Nov 19, 2020 5:03:04pm - User: rabadobh.com
 N:\PROJECTS\2551 SARAH & AMR BASTIAROS\2551.LOT THE MAPLE GROVE RESIDENCE\PHASE 03 - PERMIT ASSISTANCE\CAD\2551-LA1.1 SITE PLAN-MAPLE PERMITTING

NOTE:

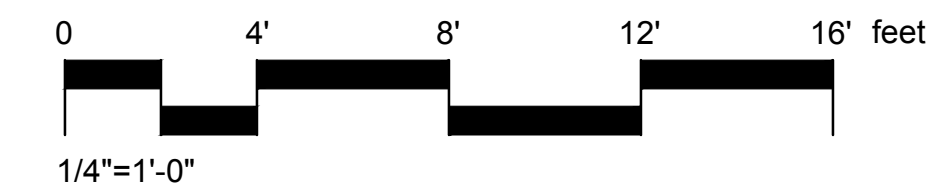
THIS SHEET HAS BEEN PROVIDED IN RESPONSE TO FIRST REVIEW COMMENTS

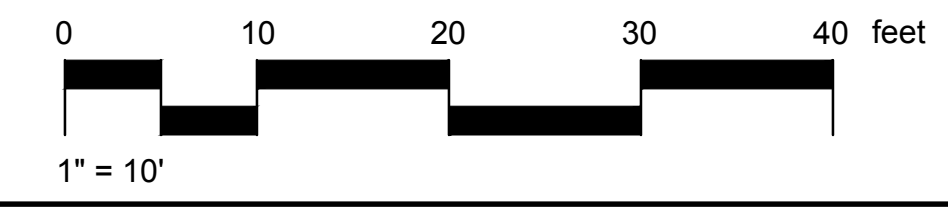
THIS SHEET HAS BEEN PROVIDED IN RESPONSE TO FIRST REVIEW COMMENTS

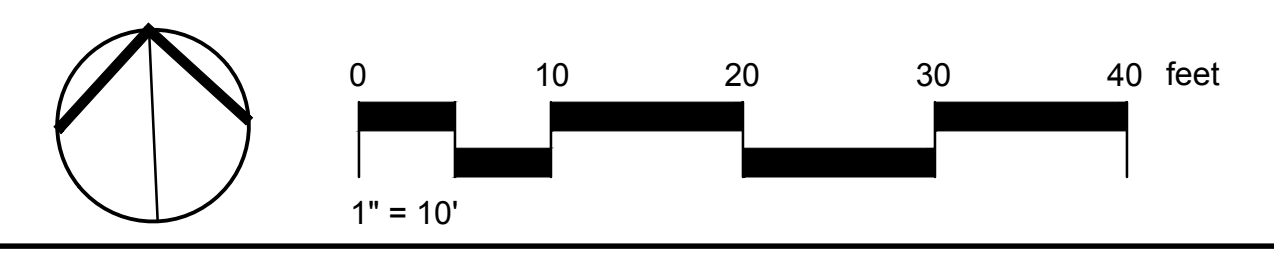
THIS SHEET HAS BEEN PROVIDED IN RESPONSE TO FIRST REVIEW COMMENTS
